OUR REF: 5941 (Stage 2-MC3)
YOUR REF: MIN/2022/245

28 March 2023

RE: MINOR CHANGE REQUEST TO DEVELOPMENT PERMIT FOR RECONFIGURING A LOT AND OPERATIONAL WORK (CHANGE TO GROUND LEVEL) – MIN/2022/245

AT: LOT 504 HOMESTEAD DRIVE, STAPYLTON QLD 4207 – LOT 504 ON SP329485 (FORMERLY LOT 502 HOMESTEAD DRIVE, STAPYLTON QLD 4207 – LOT 502 ON SP316137)

Figure 1: Approved vs. Proposed ROL Layout (GDP File, 2022)

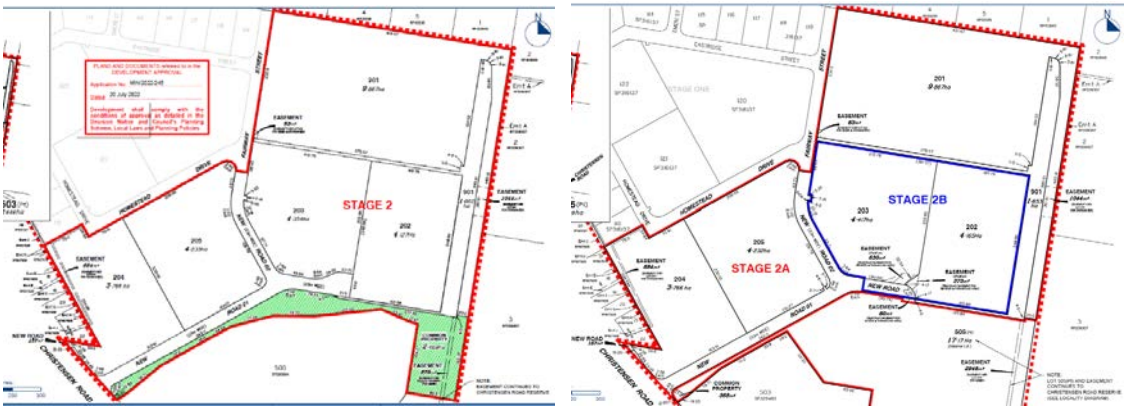
This minor change proposes the following changes to the existing approved Stage 2 layout in response to the recent boundary realignment and anticipation of the future Stage 3 subdivision:

- Realignment of ‘New Road 2’ fronting Lot 202 and 203 to facilitate a road extension into the future Stage 3 area. ‘New Road 2’ will no longer end in a cul-de-sac in front of Lot 202 and will instead provide access to future Stage 3 (which will no longer propose primary access via Christensen Road). This will align with the road network changes made to the Preliminary Approval plans.

- Change to lot boundary of Lot 205 to allow for a new pad mount transformer within ‘New Road 01’.

Comparison of the approved (left) and proposed (right) are shown in **Figure 1** below:
